Amendments to the Drawings:

The attached sheets of drawings include changes to Figures 1, 2A, 2B, 3A and 3B, which have been designated "prior art" as requested by the Examiner.

REMARKS/ARGUMENTS

This paper is submitted responsive to the Office Action mailed December 20, 2005. Reconsideration of this application in light of the accompanying remarks and amendments is courteously solicited.

Fig. 1

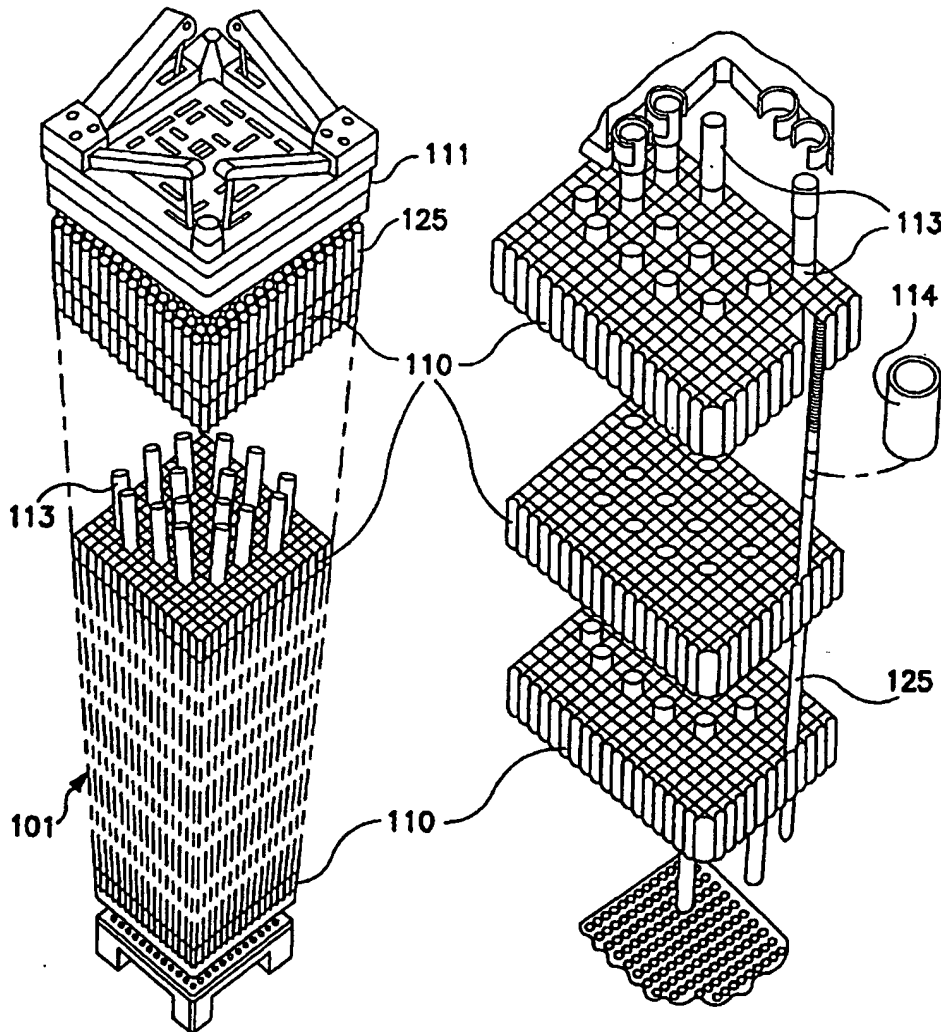
- 1. The Examiner required amendment of Figures 1, 2A, 2B, 3A and 3B.**

(Prior Art)

Added
